CITY OF SAN ANTONIO

VARIANCE REQUEST ANALYSIS

TPV 20-026

Project:	Medina River Greenway Phase 3
Address:	1349 Neal Rd, San Antonio, TX 78264
A/P #/PPR #/Plat#:	AP# 1913627
VR Submittal Date:	March 2, 2020
VR Submitted by:	Mr. Brandon Ross of City of San Antonio Parks and Recreation Department
Issue:	Below 80% significant tree and 100% heritage tree preservation within 100-Year Floodplain and Environmentally Sensitive Area (2010 Ordinance)
Code Sections:	Unified Development Code (UDC), Section 35-523 (h)
By:	Herminio Griego, Assistant City Arborist

Exhibit A: Location and current photos of the 26" Cottonwood Tree

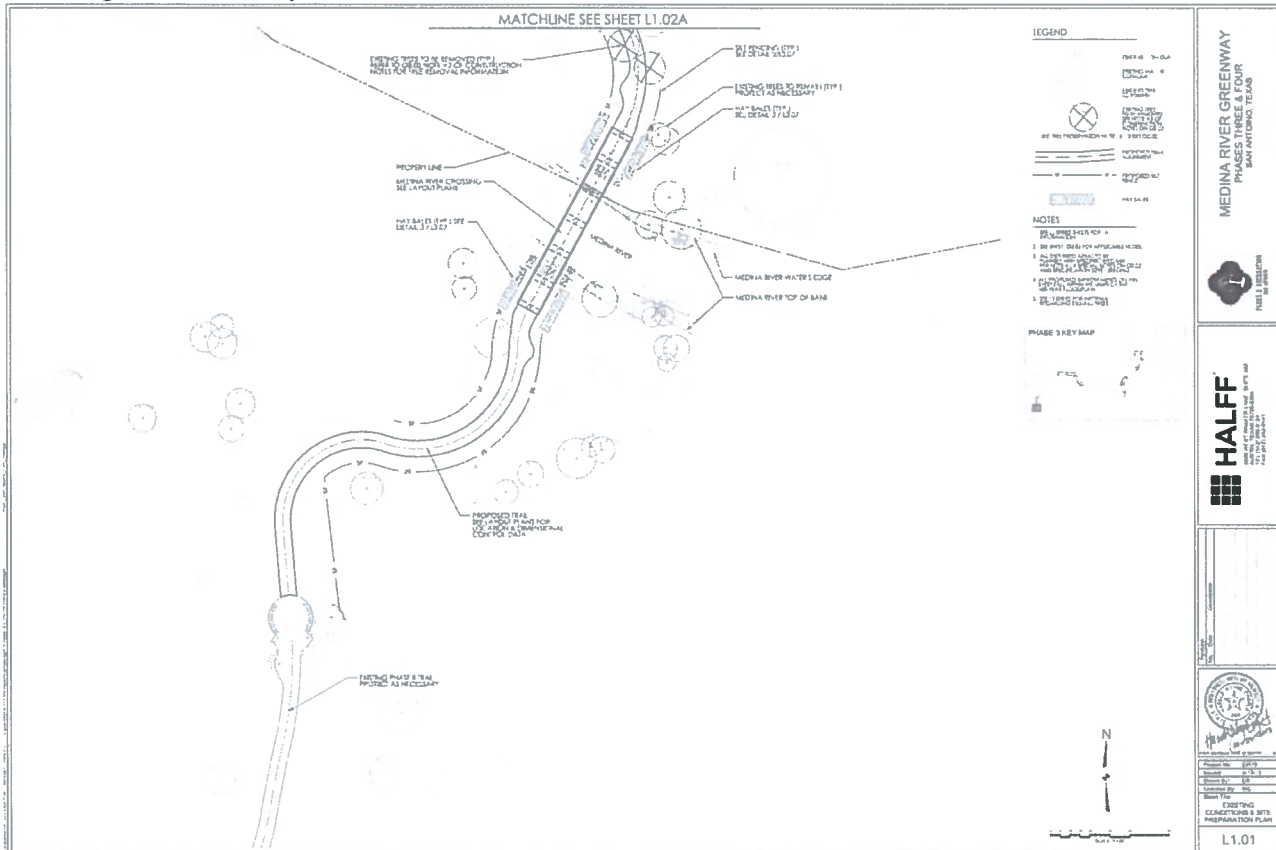
When the trees were first surveyed for the project in 2013, tree number 4099 (Cottonwood tree near the river-crossing location) measured 20 inches in diameter. A great deal of time has elapsed in the implementation of the project due to flooding, site erosion, and contracting issues. As of February 2020, tree number 4099 now measures 26 inches in diameter. Additionally, whereas the original design for the bridge across Medina River was a concrete structure requiring that piers be drilled into the river bed, the Parks and Recreation is now planning to install a pre-fabricated bridge to avoid environmental impacts and alleviate constructability concerns with drilling piers into the Medina River.

In order to place the bridge at the river-crossing location, a truck will deliver the bridge to the site through LHI property and a crane will be used to raise the bridge, orient it appropriately, and lower it onto the concrete supports (a.k.a. bridge abutments) on either side of the river. The crane will park next to the site, pick up the bridge from the trailer, rotate it in the air to the exact location, and lower it onto the supports. In order to do this, the heritage tree needs to be removed where the crane will lift and rotate the bridge from the trailer to the supports. Other alternatives have been explored, but would require more significant tree impacts. For pictures of the Cottonwood tree please see to Exhibit A. The 2013 tree survey is depicted on Exhibit B.

1. *Existing site conditions* – The Medina River Greenway Phase 3 project consists of a 3.1 mile trail from Land Heritage Institute property to the Pearsall Road Trailhead. When the trees were first surveyed for the project in 2013, tree number 4099 measure 20 inches in diameter. A great deal of time has elapsed in the implementation of the project due to flooding, site erosion and contracting issues. As of February 2020, tree number 4099 now measures 26 inches in diameter. Additionally, whereas the original design for the bridge across Medina River was a concrete structure requiring that piers be drilled into the river bed, the Parks and Recreation department is now planning to install a pre-fabricated bridge to avoid environmental impacts and alleviate constructability concerns with drilling piers into the Medina River. In order to place the bridge at the river crossing

location, a crane will need to be utilized and tree number 4099 will need to be removed. The required mitigation for the removal of the 26 inch Cottonwood is 78 inches.

DSD staff supports the applicant’s request to fall below 100% of heritage tree preservation requirements within the Environmentally Sensitive Area (ESA) based on the conditions of the site, design constraints, and exceeding mitigation requirements. The proposed Variance Request meets the intent and spirit of the Tree Ordinance therefore, staff recommends approval.

Exhibit C: Proposed Tree Mitigation Plan (Site Plan and Tree List) – see attached

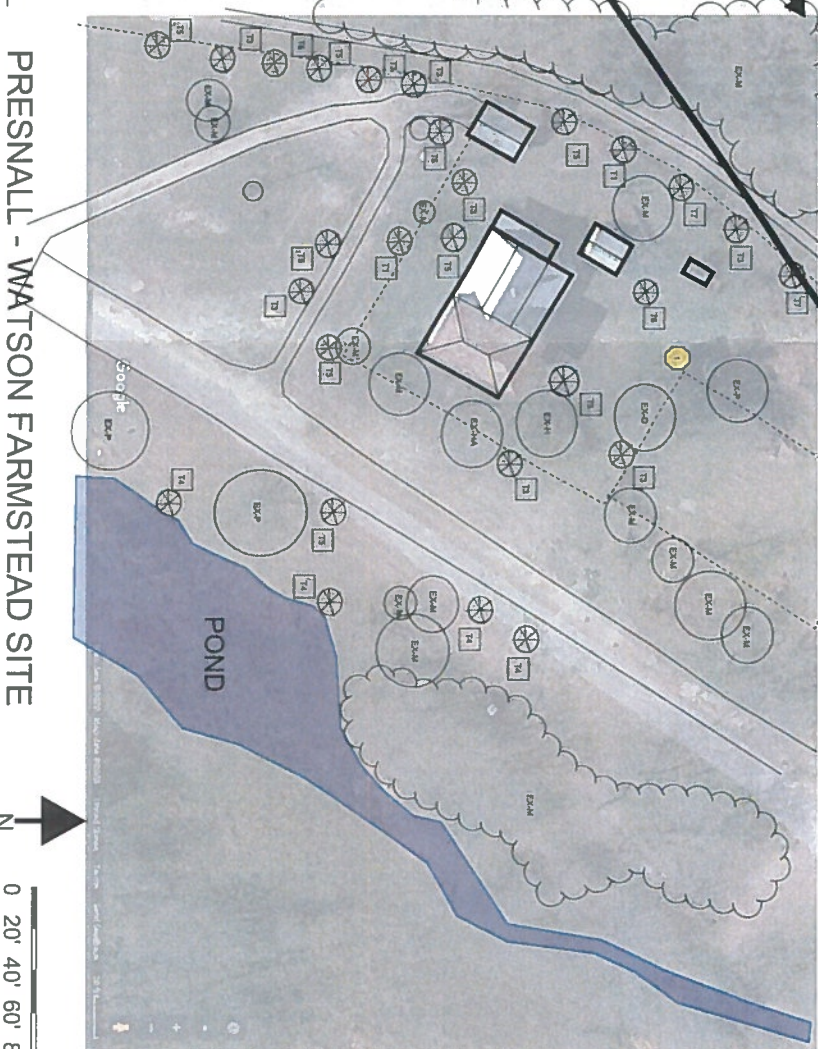
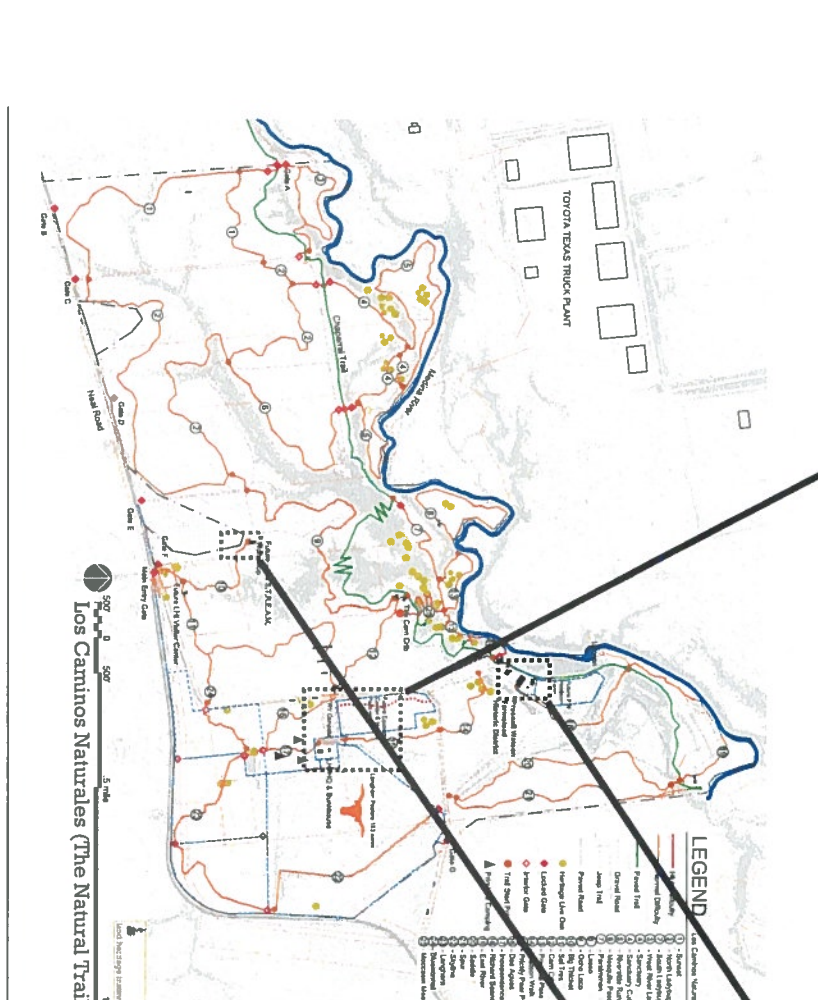
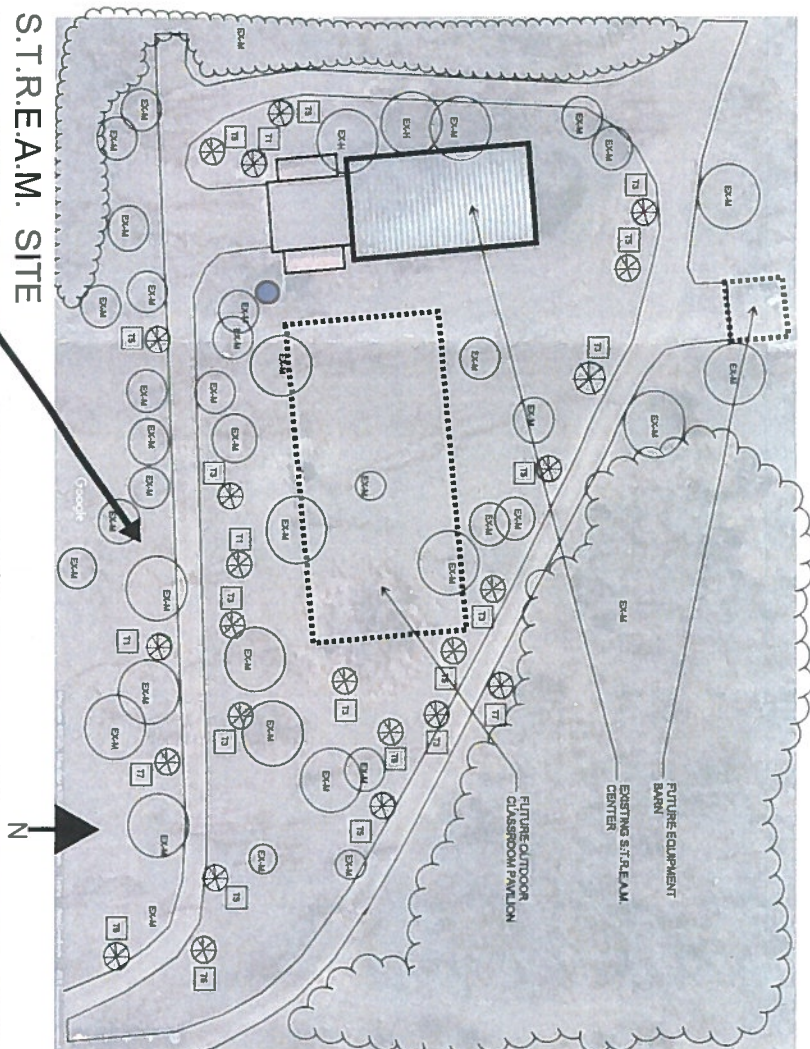
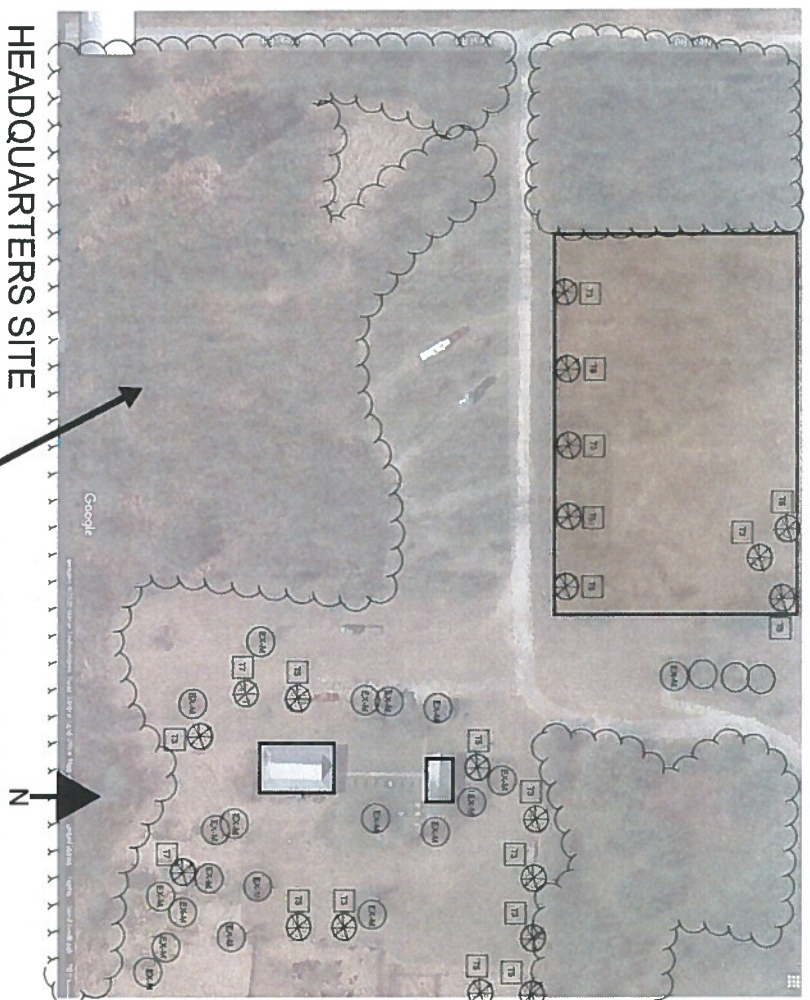
Because the tree impacts are on property owned by the Land Heritage Institute (LHI), LHI representatives have requested that the City's Parks and Recreation Department pay for the tree to be mitigated onsite and with the oversight of LHI management. Mitigation funds of \$15,600 (26 inches X \$600 per inch) will be paid to LHI to perform the site preparation, tree plantings, and maintenance to get the trees established. For the proposed Tree Mitigation Plan (including site plan and tree list) please see Exhibit C.

2. *Tree mitigation* - The project will exceed the required mitigation of 78 inches by planting (70) – 1.5 inch to 2 inch caliper native medium to large shade trees for a total of 106.5 inches planted back on Land Heritage Institute (LHI) property. LHI will perform the site preparation, tree plantings and maintenance to get the trees established. The proposed planting plan provides added species diversity to include native medium and large shade tree species per Appendix E “San Antonio Recommended Plant List.” Trees proposed to be planted for mitigation include: Bur Oak, Mexican Sycamore, Pecan, Cedar Elm, Live Oak and Monterey Oak.
